LATCHMERE HOUSE

Summary of Changes

The intention of the revised design is to optimise the use of the large reception rooms on the Ground Floor.

Original Ground Floor

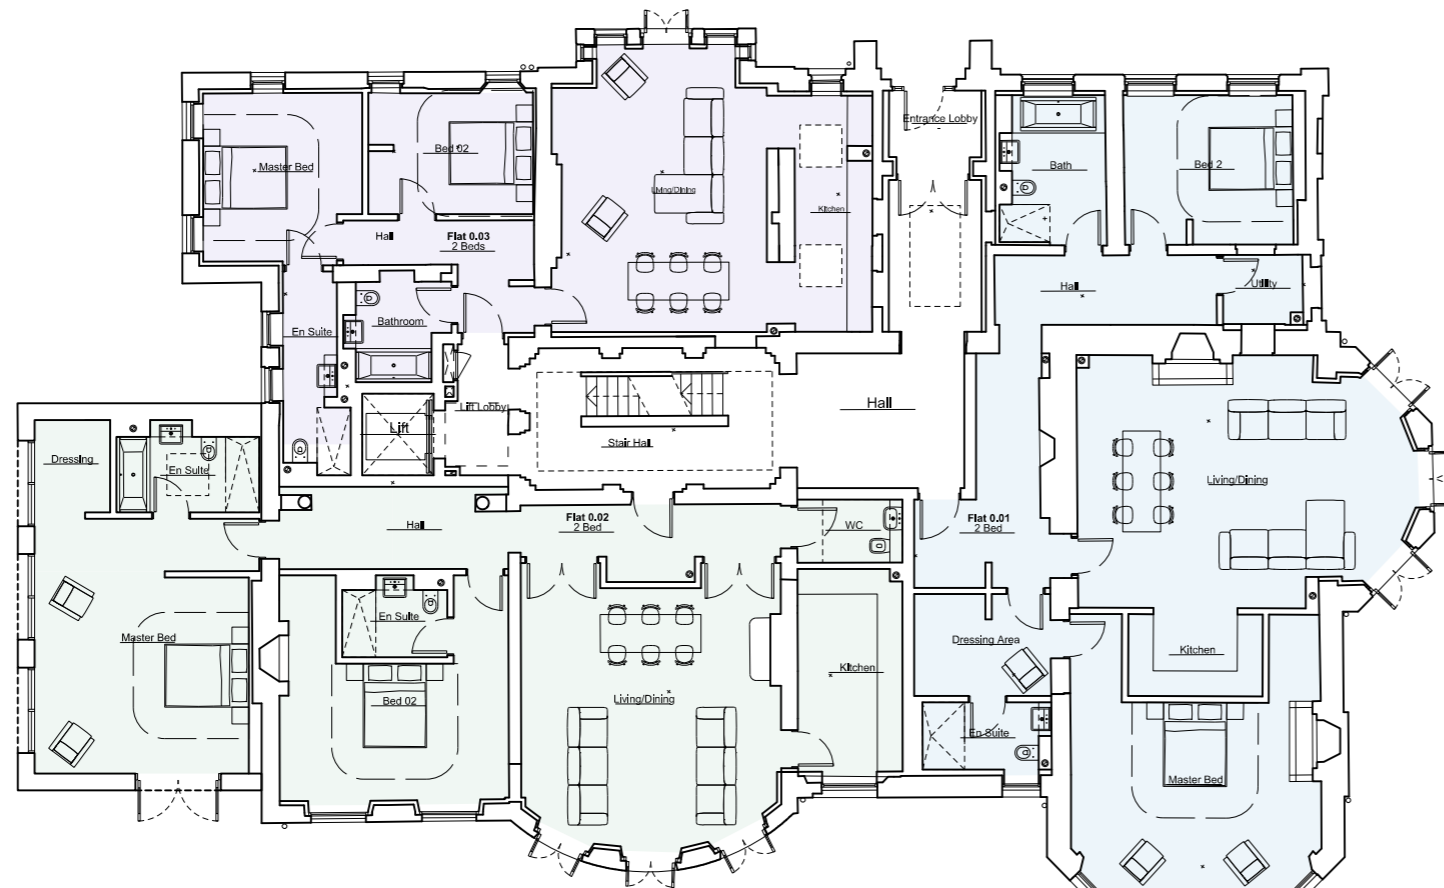
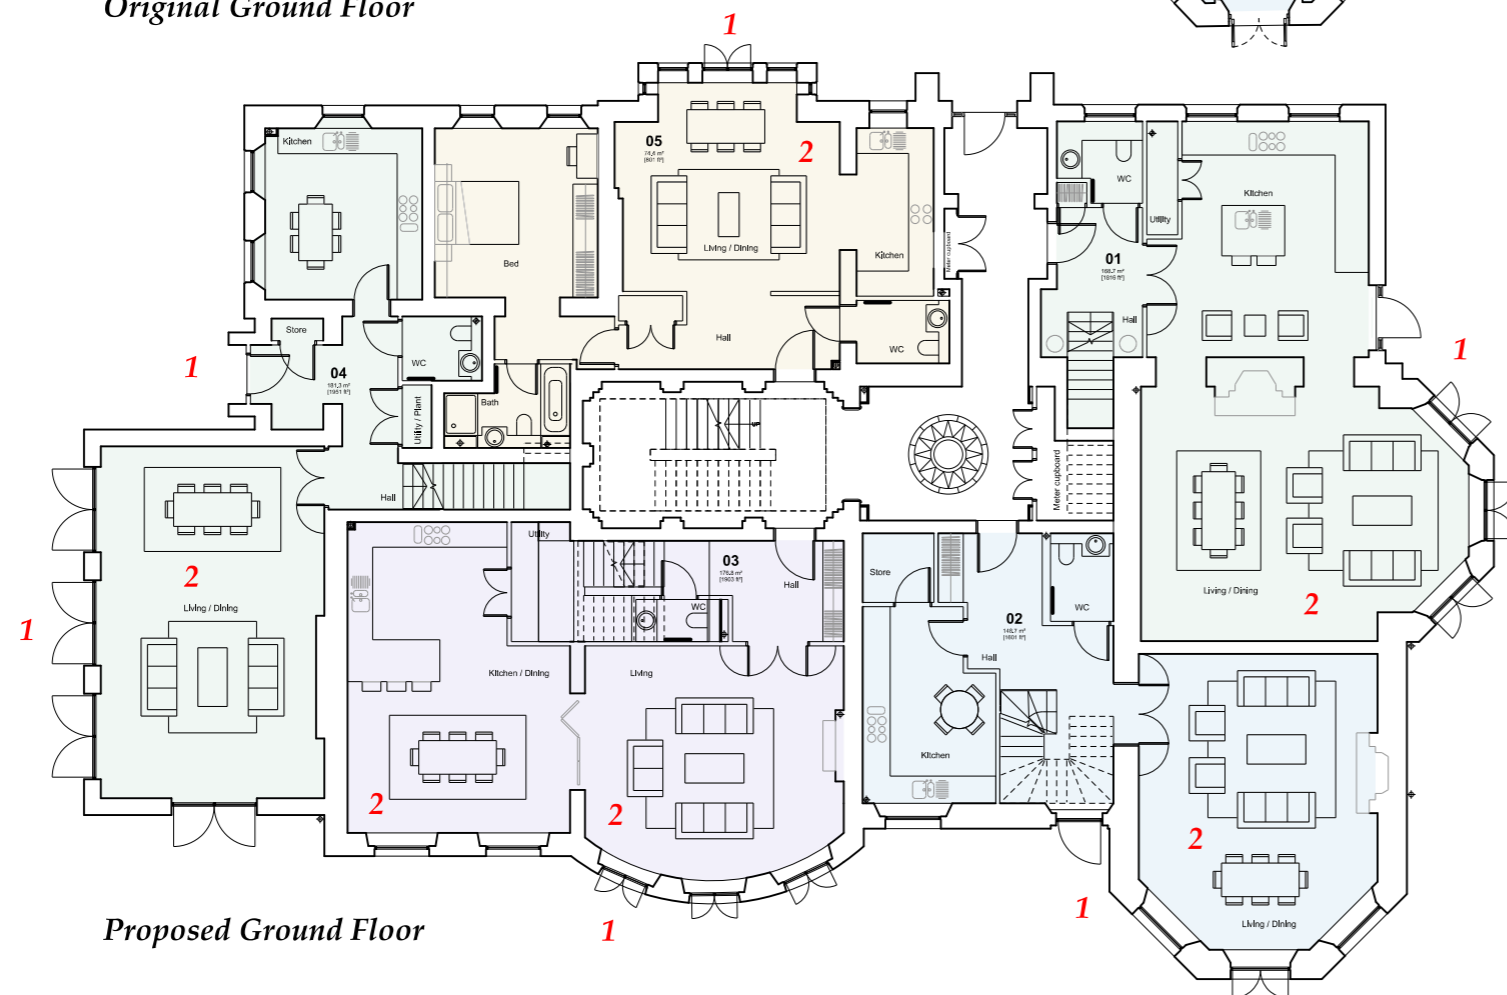
The original application was for seven flats; three on the Ground Floor, two on the First Floor and two on the Second Floor. This revised design proposes to keep the two Second Floor flats but use the Ground and First Floor to provide 4 duplex apartments and one Ground Floor apartment. As a result;

1. Five of the apartments have a direct connection with ground level.
2. All the principal reception rooms can be used as living rooms and not bedrooms.
3. The lift is no longer necessary, as only the two second floor flats are accessed from above ground level. This results in less demolition and a more sympathetic treatment of the original fabric.
4. The only change to the external design from the original application is a new entrance door on the south west façade and a small variation in window arrangement on the same elevation.

First Floor Comparison

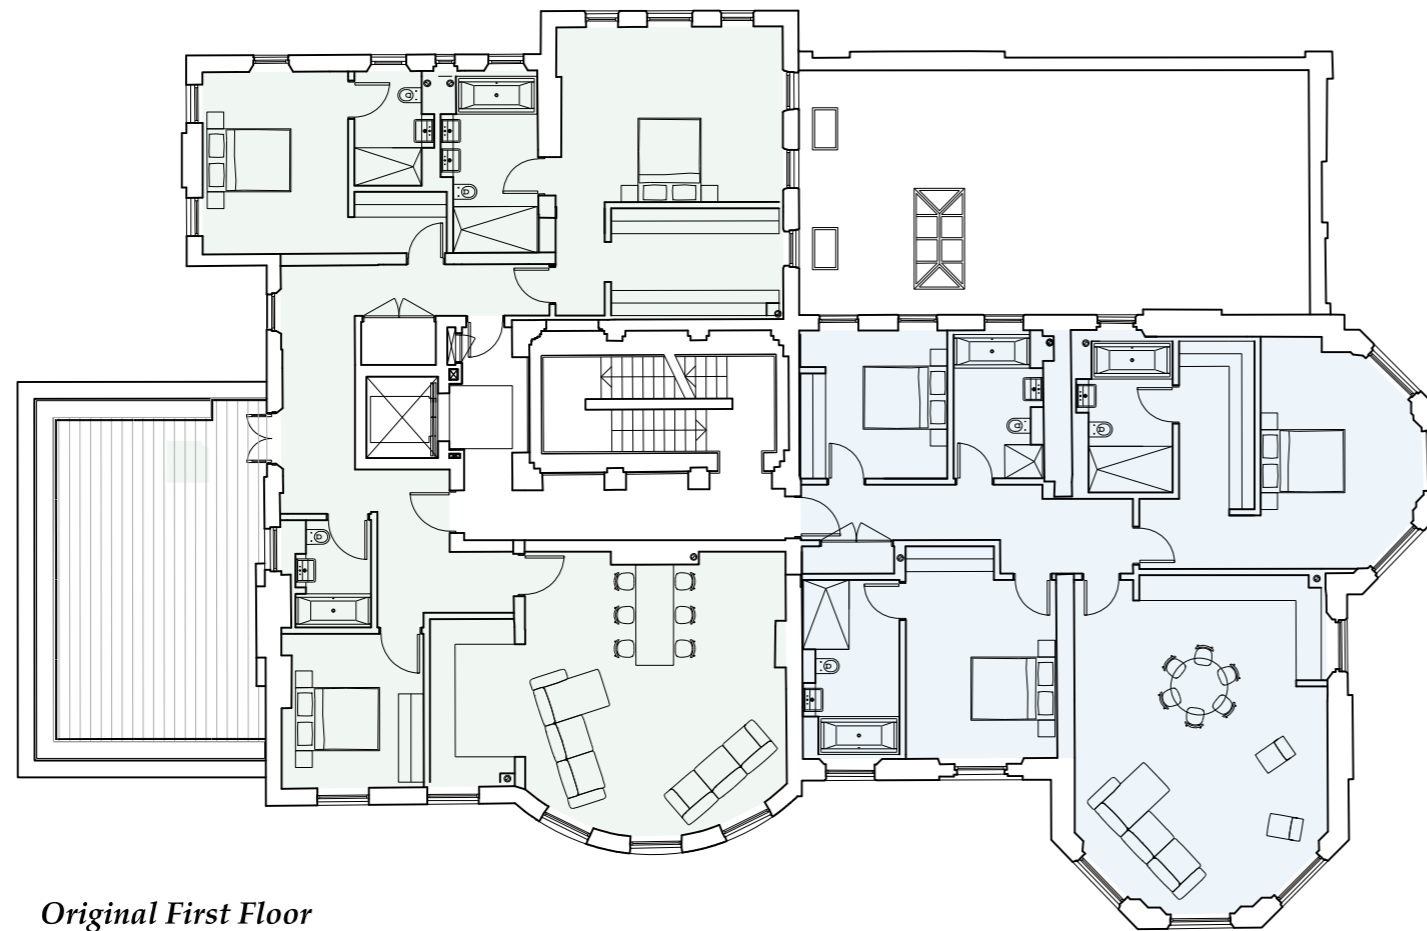
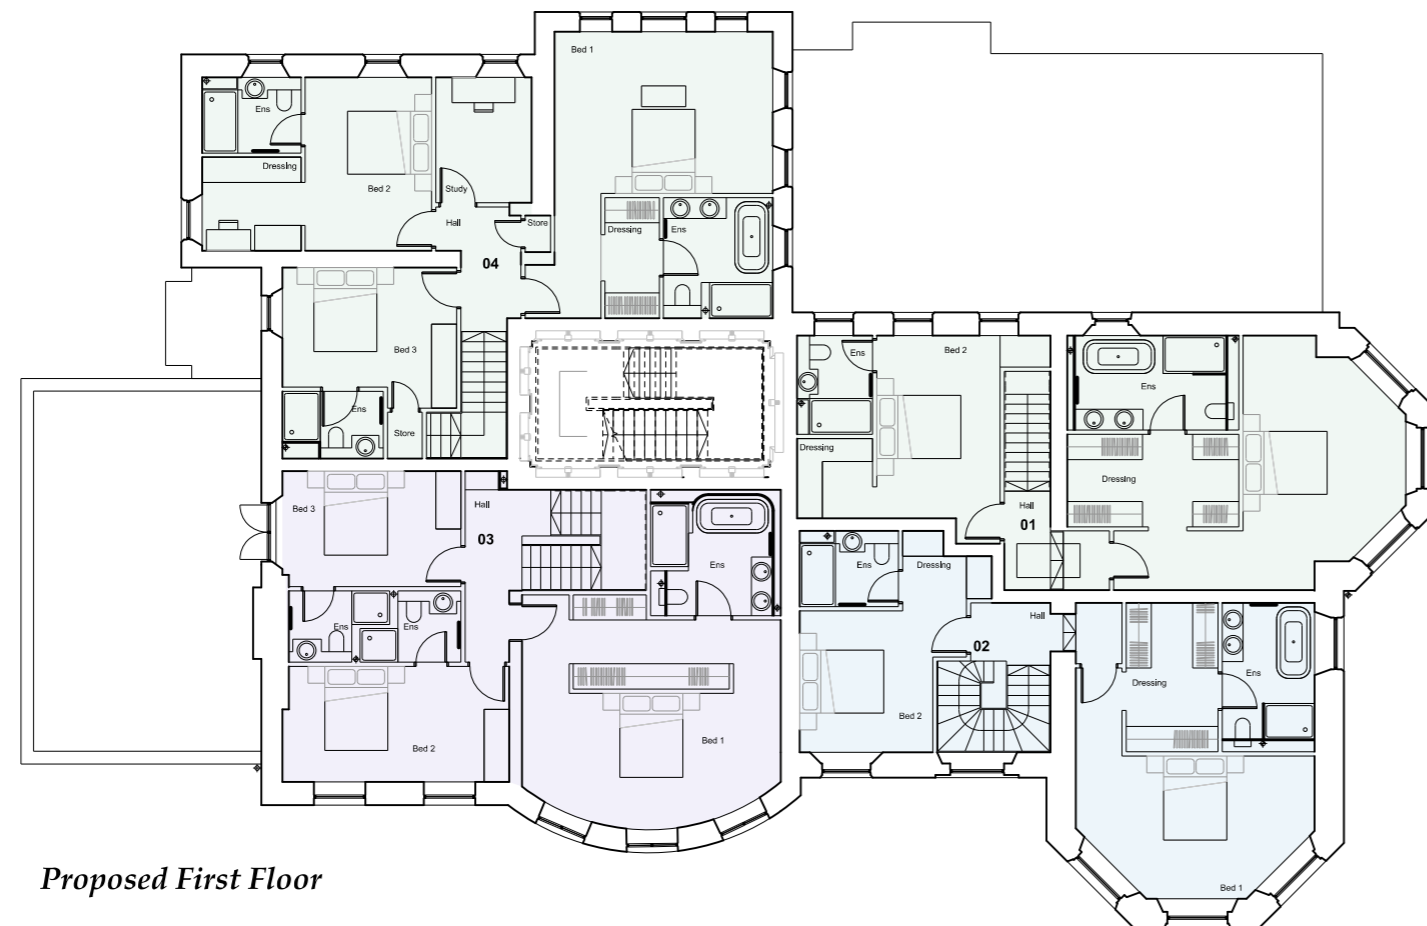
The duplex arrangement allows the First Floor rooms to be used as bedrooms instead of living rooms. Access to this floor from the common core is not required.

Second Floor Comparison

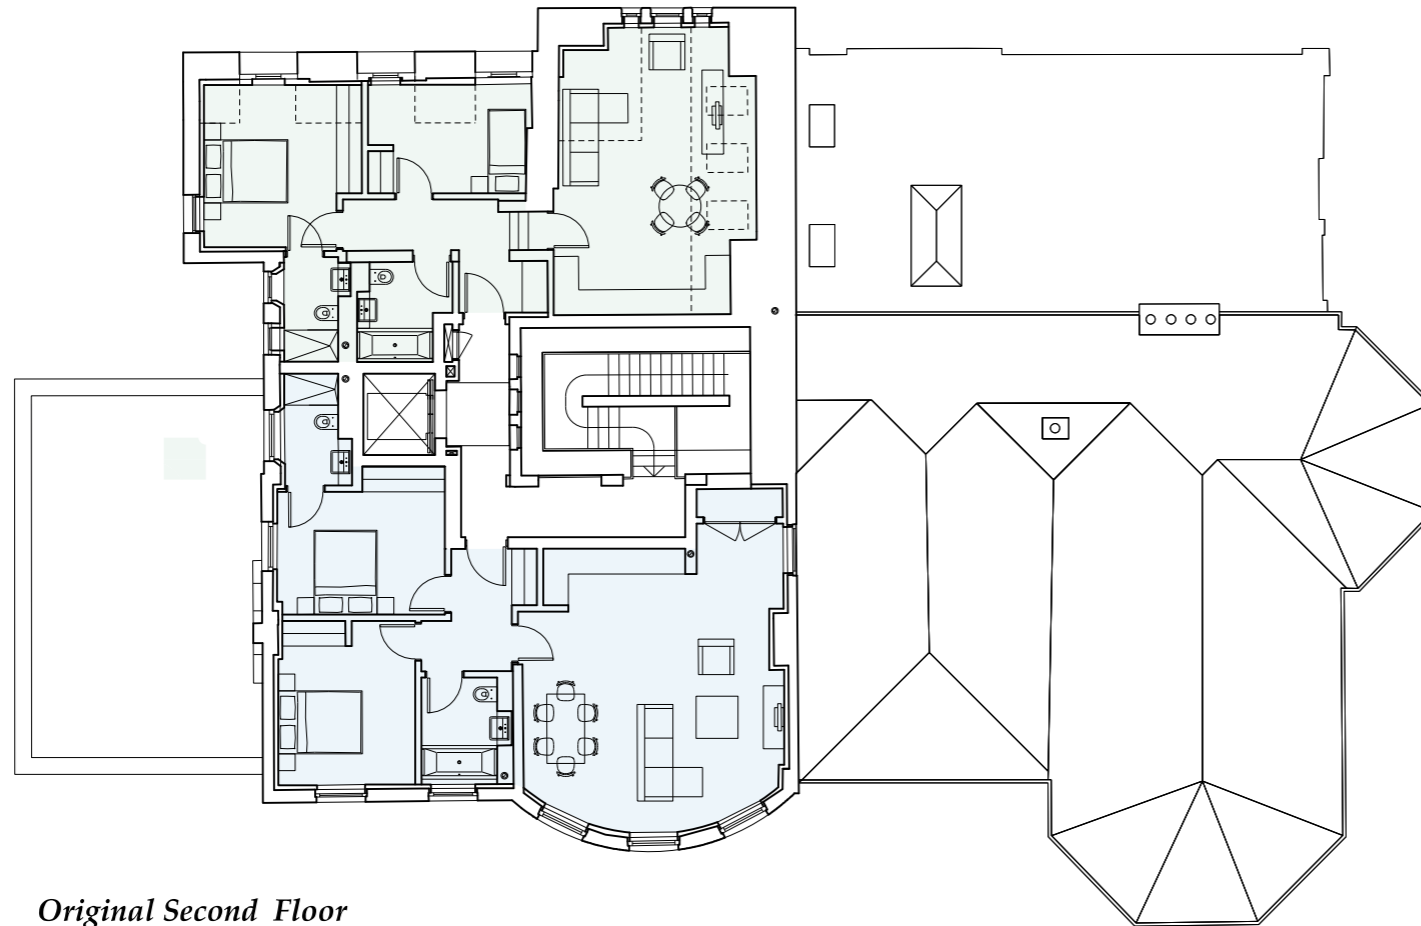
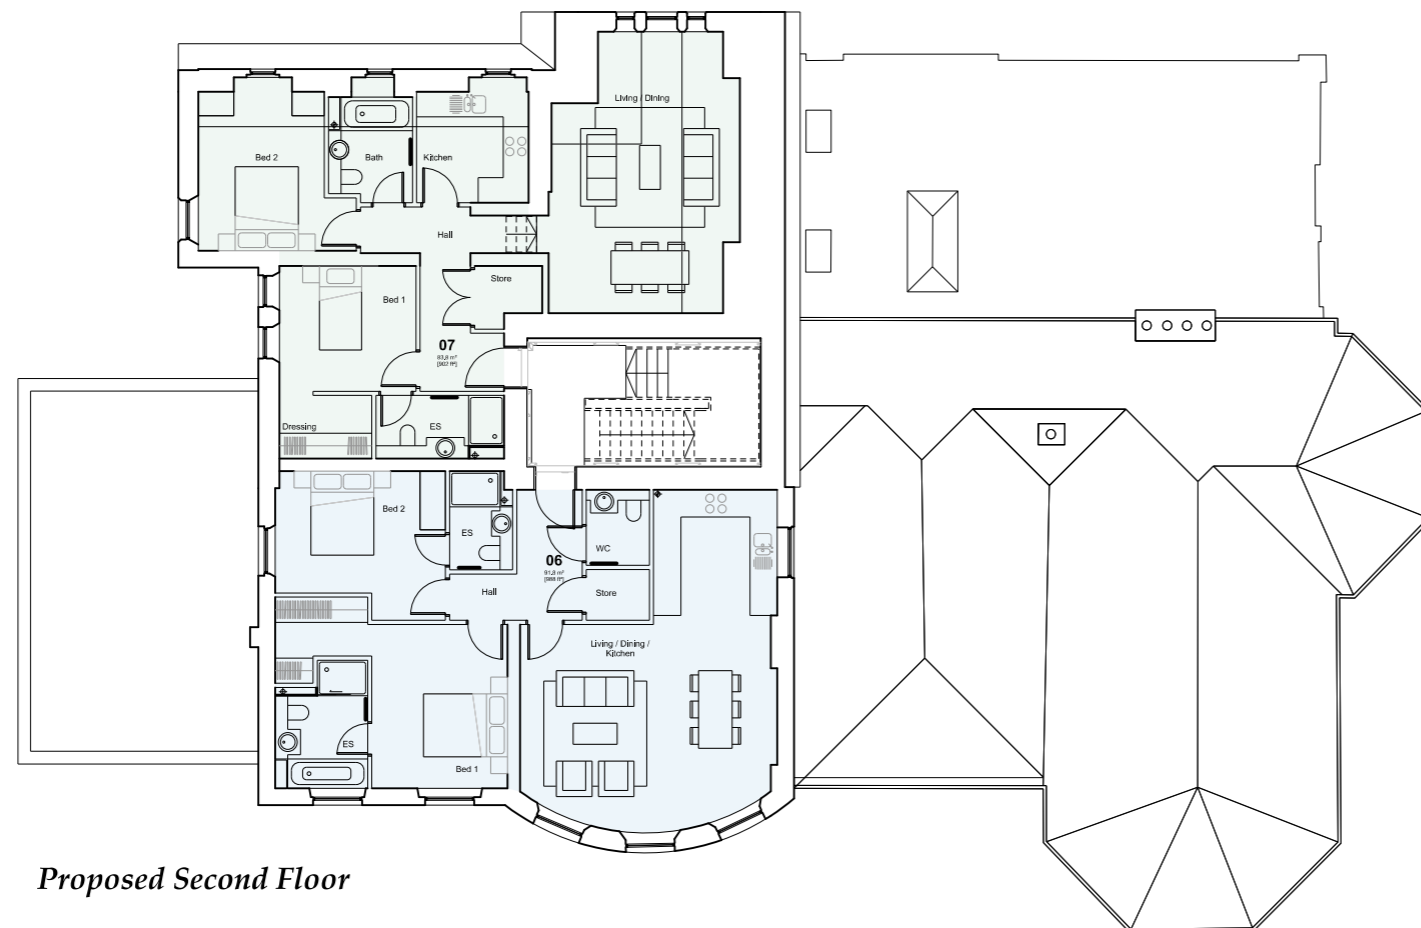
Better use of the Second Floor can be made by avoiding a lift and the demolition and new structure it requires.
